The New Piper Aircraft, Inc.
2926 Piper Drive
Vero Beach, Florida, U.S.A. 32960

SERVICE No. 1020 BULLETIN

**Inspection of the ARTEX 110-4 ELT and
ELT Attachment Bracket**

**ELT Battery Pack
(Severe Damage from Battery Venting)
REPLACE UNIT**

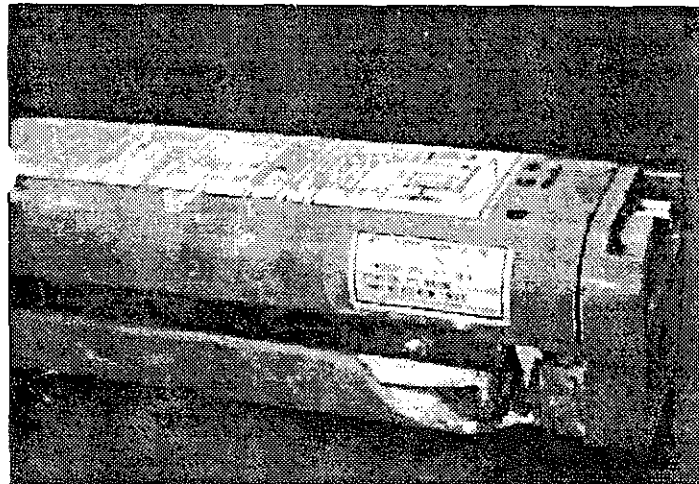
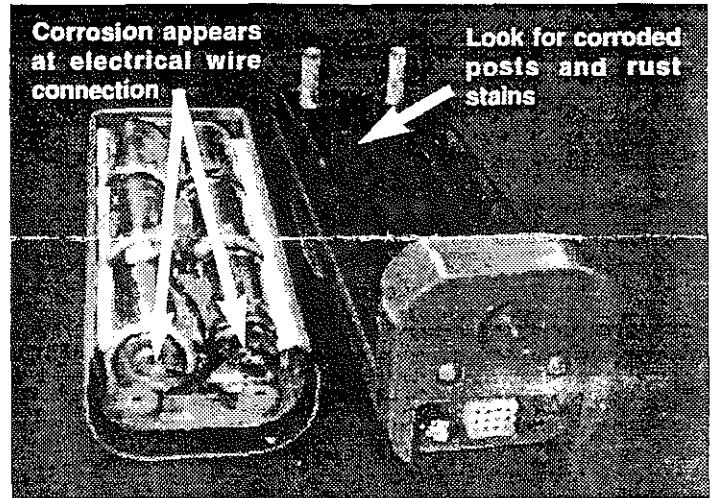
3. If the ELT battery pack does not pass the criteria as set forth in the ARTEX publication, the ELT battery pack must be replaced with a new ELT Battery Pack, Piper Part Number 758-696. *(See the data tag and corrosion photographs on page 3.)*

5. If the ELT battery pack has cracked or leaked acid, it will be necessary to inspect the bracket attaching the ELT for corrosion. If other than surface corrosion is found, replace the bracket. If a replacement bracket is required, refer to the applicable Piper Illustrated Parts Catalog to obtain the appropriate part number.
